The Allston I-90 Throat & History

Mitigation Issue #1:

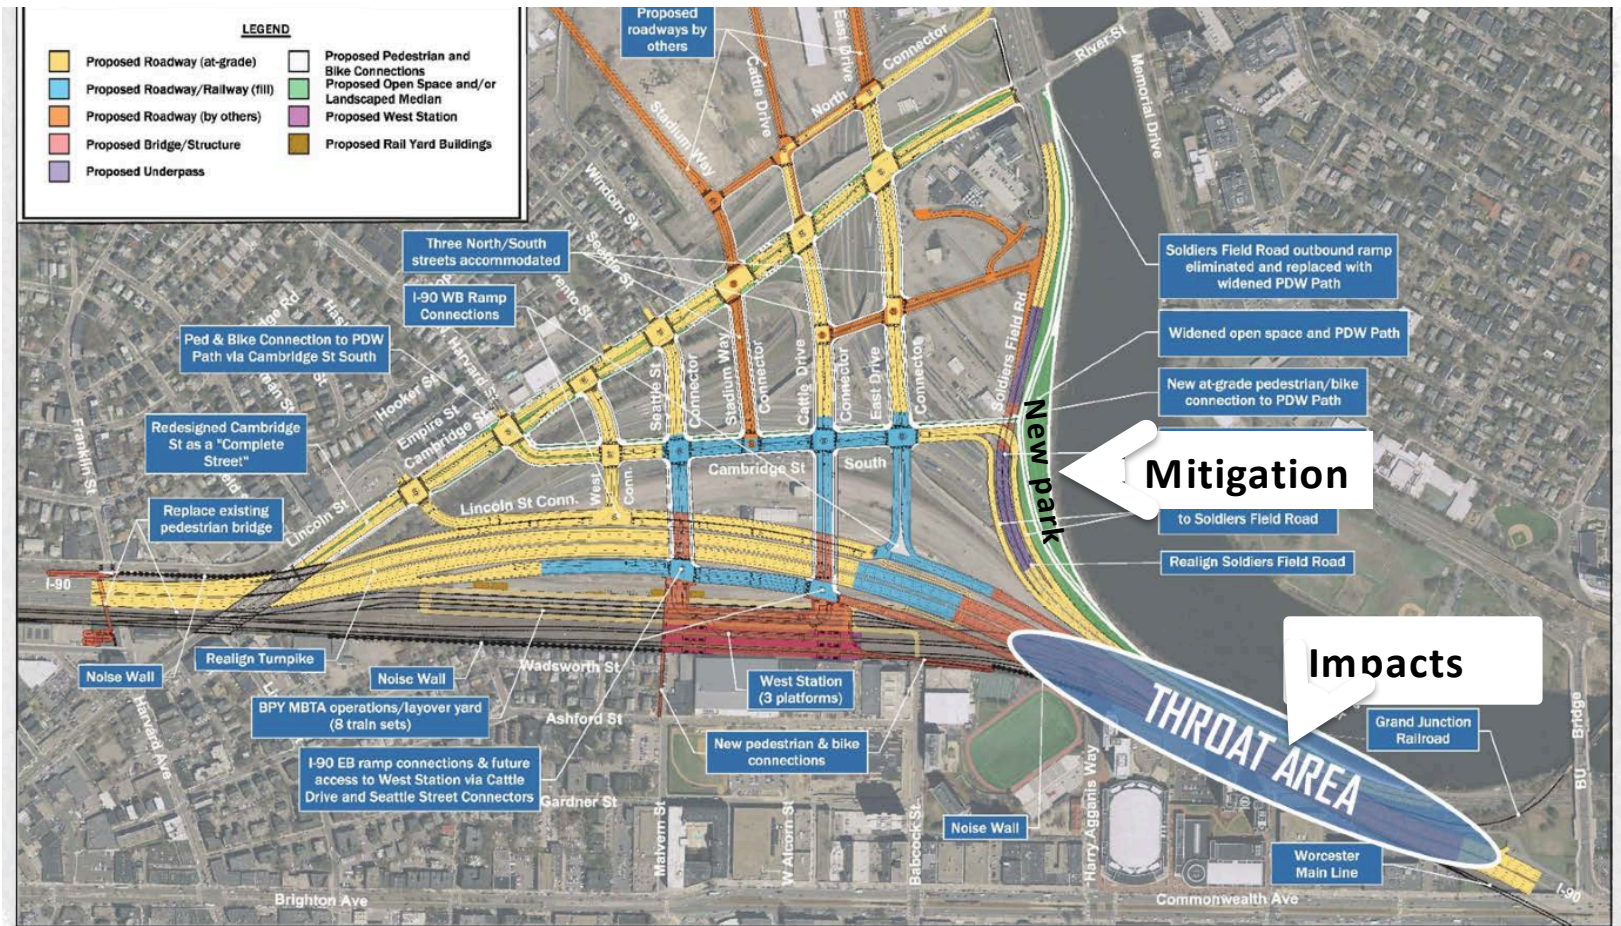
2018 – Although the landscape area along the river in the Throat is a steep, crumbling, and eroding bank, it was not recommended for restoration in the DEIR.

(except for brush and tree removal shown in DEIR renderings).

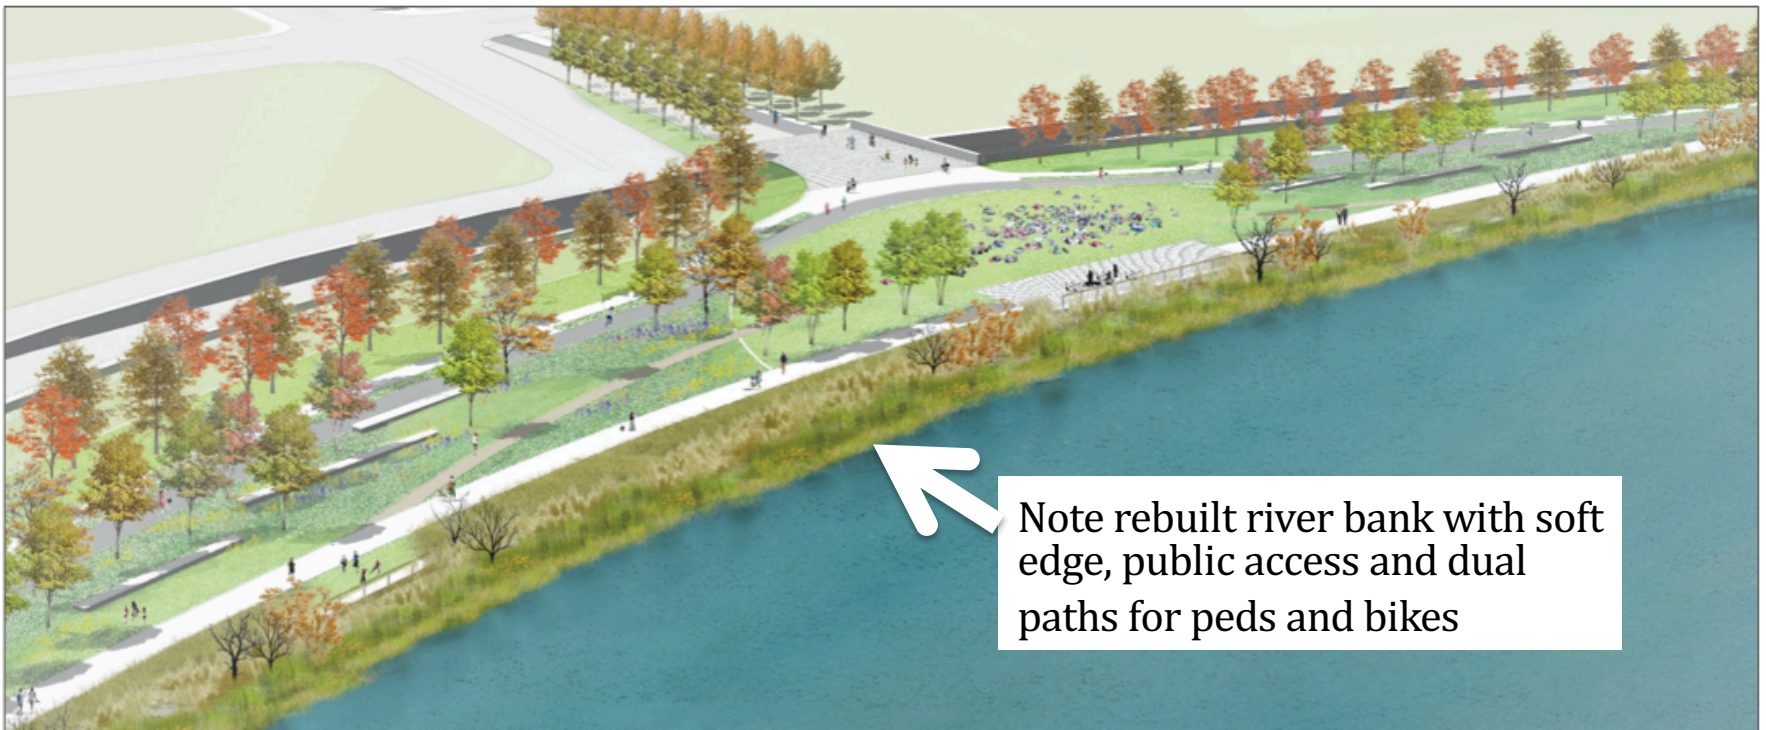
MassDOT has developed a mitigation plan for highway impacts to the Charles River Historic District- but only in the expanded park 1000' away from the Throat.

Note rebuilt river bank with soft edge, public access and dual paths for peds and bikes
